Product Change Notification / ALAN-03HTZP673

CCB 4993 Final Notice: Qualification of 3280 die attach material and new lead frame design for selected products available in 8L SOIC package assembled at MMT assembly site.

CCB 4993
Pre and Post Change Summary
PCN# ALAN-03HTZP673

Pre Change

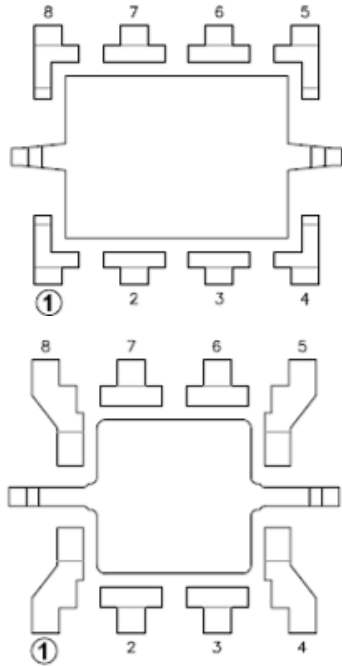
Lead-lock

No

Post Change

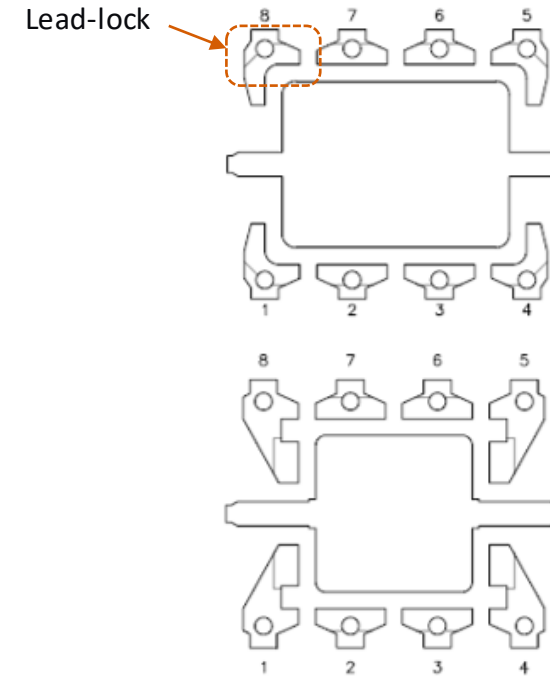
Lead-lock

Yes

Note: Mold compound materials fills the leadlockhole, which provides improved protection against moisture penetration along the edge of the leads (pins) of the package.
